**ADDENDUM #2
PROJECT: COMPOSITES AUTOCLAVE
BID NO.: RFP No. AVC2017/2018-14**

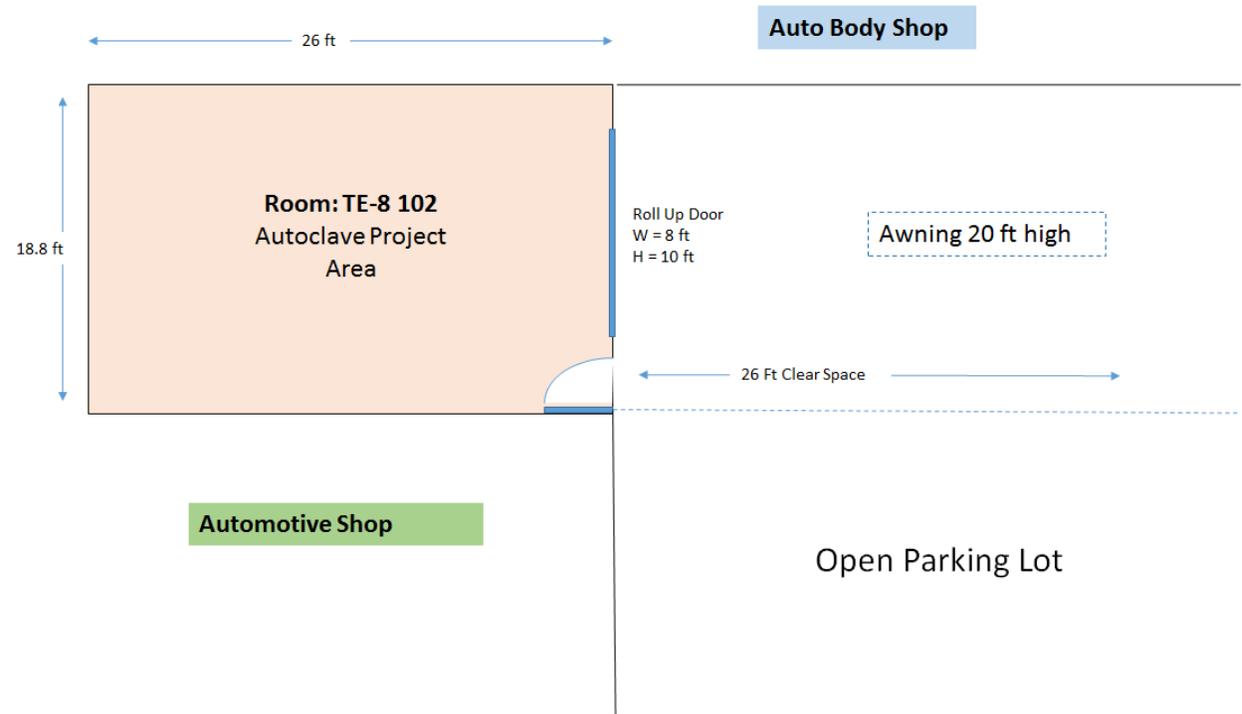
Q-1. Could you provide standard free and clear area and utility w/in so many ft, etc ?

Q-2. Could you please provide location (location install and where could unload and sizes /dims between there and install location)?

A-1. Access to project room is through parking area with at least 30 ft of clearance around room entrance; see drawing below (not to scale). The utility hookups will not be provided by the awarded vendor as it will be work performed after the equipment is installed and once we know the specific utilities the equipment needs. Some utilities are available in the installation location (drain, water, air) and others can be added to the room (ventilation).

A-2. Autoclave will be installed at the following address:

Antelope Valley College, Technical Education – Auto Body, Room TE8-102, Lancaster, CA 93536.

- Room floor plan dimensions are: 18.8 ft Wide x 26 ft Long X 18 ft High

- Roll up Door: 8 ft wide x 10 ft High
